## **APPENDIX D: PERTINENT CORRESPONDENCE**

**APPENDIX D.1: U.S. FISH AND WILDLIFE  
SERVICE AND NATIONAL MARINE  
FISHERIES SERVICE CORREPONENCE**

**D.1 U.S. Fish and Wildlife Service and National Marine Fisheries Service Correspondence**

**FIGURE 2. CEPP RECOMMENDED PLAN SOUTHERN DISTRIBUTION AND CONVEYANCE FEATURES AND LOCATION (USACE 2014).**

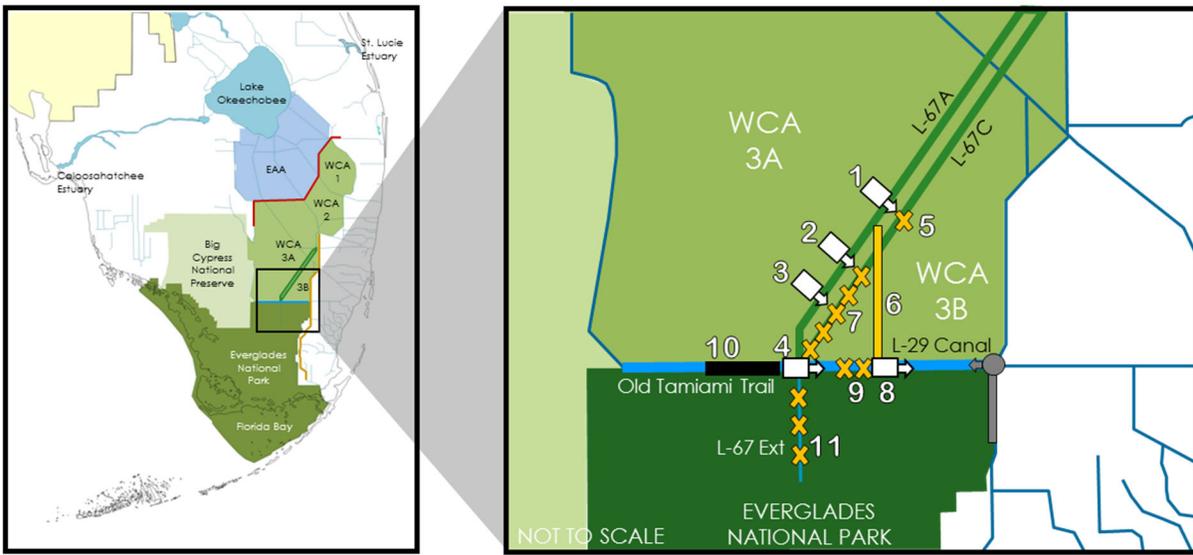
The BA lists all the CEPP South features in Table 1 (page 8), Figure 2 (page 9), and provides a description of these on pages 11 through 14. The new S-356 pump station is not listed on Figure 2. Similarly, the S-355W gated spillway is not listed in Table 1. Please provide corrected versions of Figure 2 and table listing all CEPP South features.

*USFWS Comment: The BA lists all the CEPP South features in Table 1 (page 8), Figure 2 (page 9), and provides a description of these on pages 11 through 14. The new S-356 pump station is not listed on Figure 2. Similarly, the S-355W gated spillway is not listed in Table 1. Please provide corrected versions of Figure 2 and table listing all CEPP South features.*

Response: Table 1 in the 2020 CEPP South BA references a “L-29 Gated Spillway”. The term “S-355W gated spillway” is another way to refer to the “L-29 Gated Spillway”. Table 1 has been updated below. Figure 2 in the 2020 CEPP South BA shows the location of S-356 noted as a “Yellow Line Feature”. This figure was pulled from the 2014 CEPP Final PIR/EIS, in which the authorized project features were graphically represented by: (1) North of the Redline (Storage and Treatment); (2) South of the Redline (Distribution and Conveyance); (3) Blue and Green Lines (Distribution and Conveyance) and; (4) Yellow Line (Seepage Management). S-356 is represented as feature number “1” in Figure 1 below. Please use this figure, in addition to that already included in the 2020 CEPP South BA for purposes of clarifying the location of S-356.
